E8361A-04

S E R V I C E N O T E

E8361A PNA Microwave Network Analyzers

Figure 1: A3 Front Panel Interface Board Assy without the Bracket

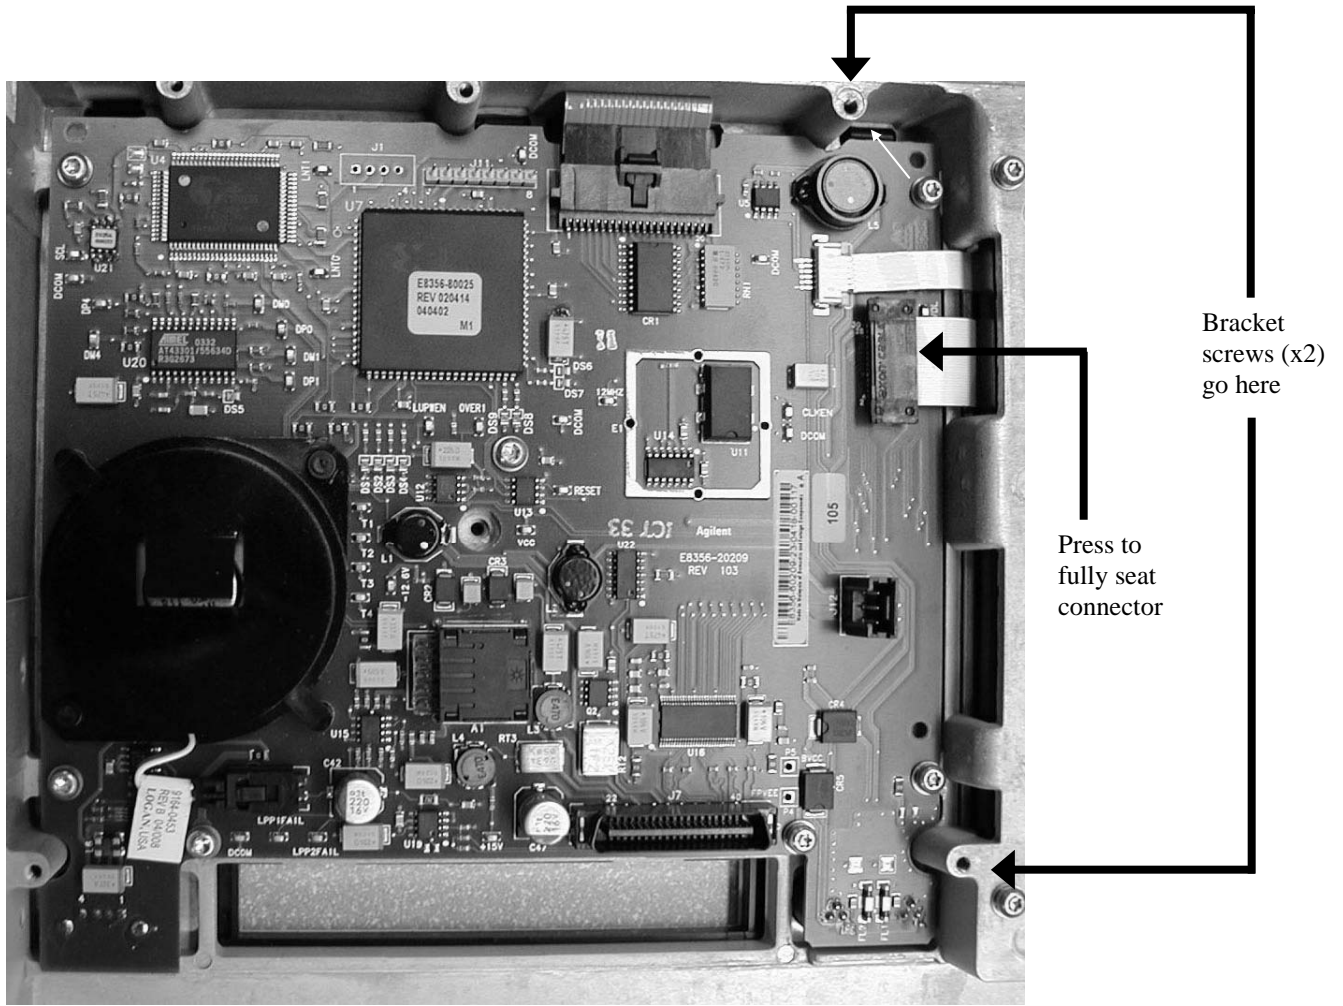
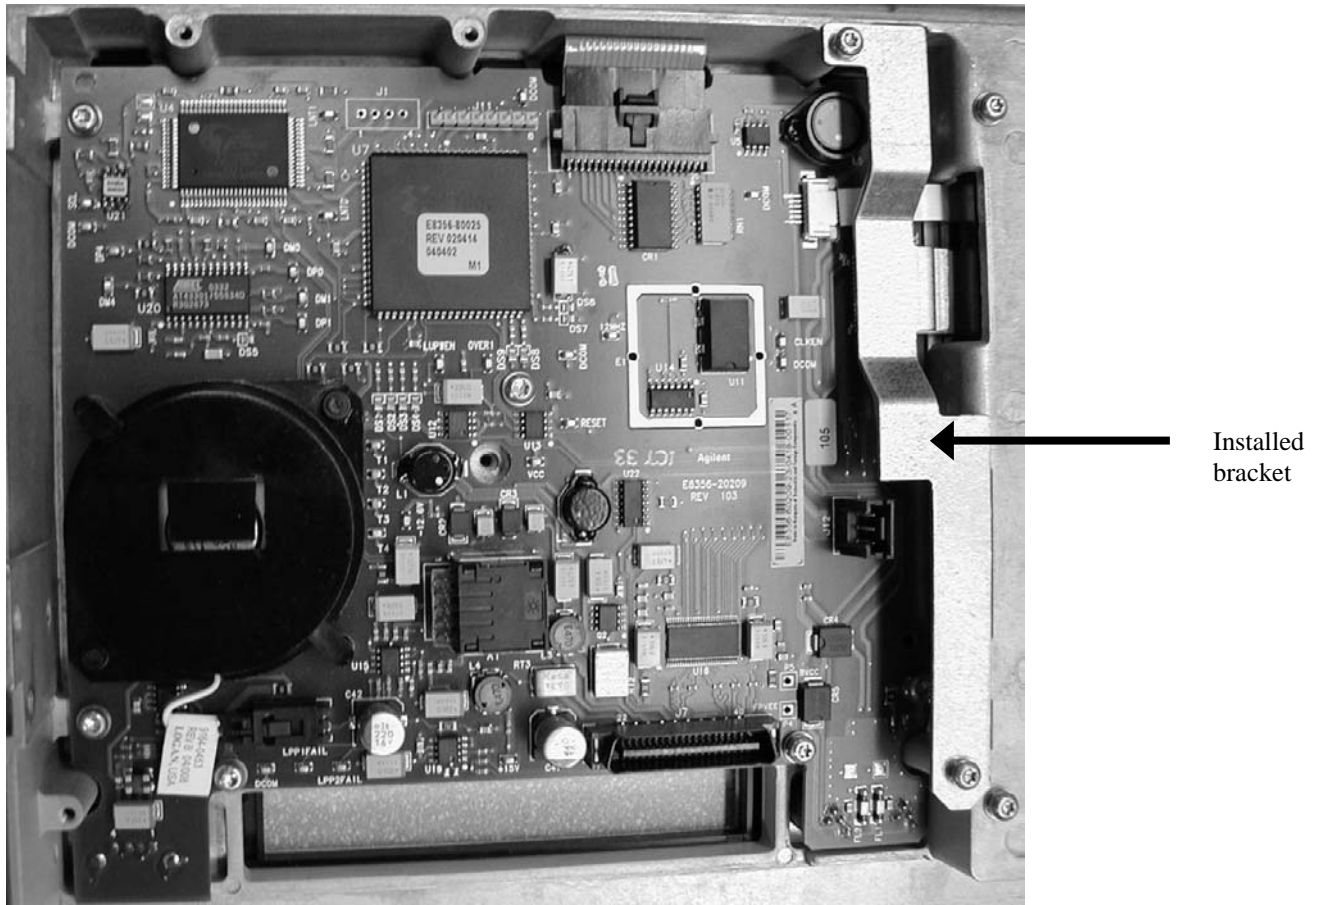
A connector of the ribbon cable (Agilent part number 8120-8409) that joins the front panel display to the front panel interface board can loosen, causing a display failure, unless a new bracket is installed. Because the failure rate has been very low, it is recommended that the bracket be installed only when there is an additional reason to remove the PNA front panel.

1. Refer to Figure 1 in this document:
 - Press down firmly on the ribbon cable's black connector.
 - Locate the two tapped holes for the bracket screws.
2. As shown in Figure 2 in this document, position the bracket so that its holes line-up with the two holes you located in the previous step.
3. Hand-start the two screws, and then torque both to 9 in-lbs.
4. Reinstall the PNA Front Panel by following the Service Guide instructions in the "Replacement Procedure." This is located on the same page as the "Removal Procedure" used previously in step 7.
